## MPC8309 Chip Errata

This document details all known silicon errata for the MPC8309. The following table provides a revision history for this document.

**Figure 1. Recommended connections for DDR controller and memory**

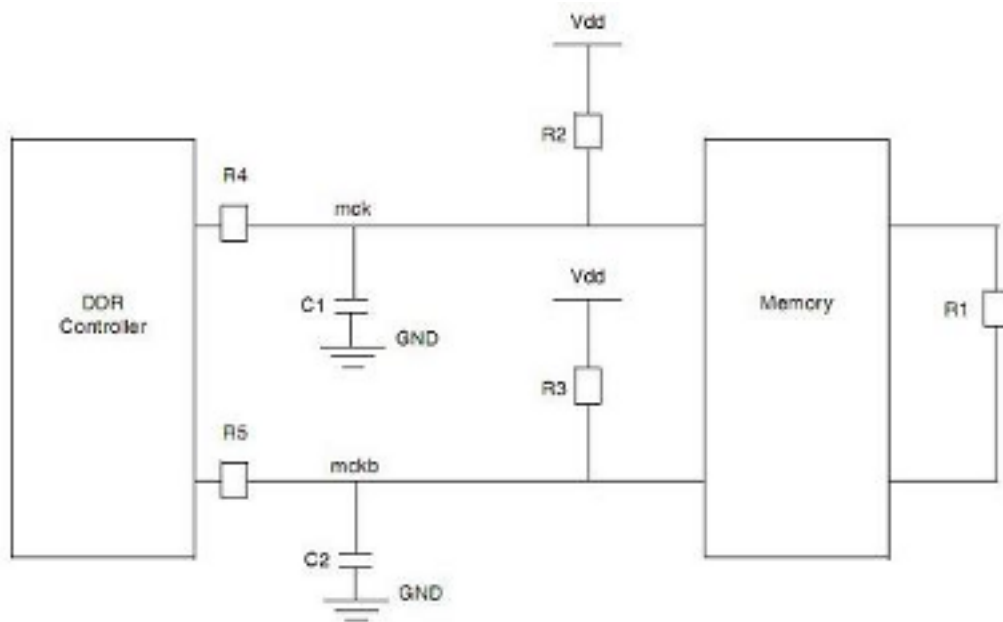
## DDR21: MCK/ $\overline{\text{MCK}}$ AC differential crosspoint voltage outside JEDEC specifications

**Description:** The crossover points of the MCK and  $\overline{\text{MCK}}$  signals of the DDR controller are not meeting JESD79-2C specifications, which indicates that the crossover points should lie within  $\pm 125$  mV range of reference voltage.

**Impact:** Disagreement with the JESD79-2C standard.

**Workaround:** To meet the JESD79-2C crosspoint voltage specifications, we recommend implementing the following connections between the DDR controller and DDR2 memory:

Effect of different circuit components on MCK and  $\overline{\text{MCK}}$  signals:

1. Increasing R2 and R3 shifts signal levels up (used as pull up).
2. Increasing C1 increases rise/fall time of mck signal.
3. Increasing C2 increases rise/fall time of mckb signal.
4. Reducing R1 can help in shifting the signals up.
5. R4 and R5 can be used to make termination proper.

R4, R5, C1, C2 near to SOC, R1, R2, and R3 have been placed at the end of clock transmission lines.

We recommend varying termination resistor R1 first. Lowering R1 can help increase the voltage levels up. The only disadvantage is that it may add up more reflections. Therefore, the user must decide accordingly. If it does not give sufficient margin, the user can add the pull-up resistor (R3 and R4) option to further increase the voltage levels.
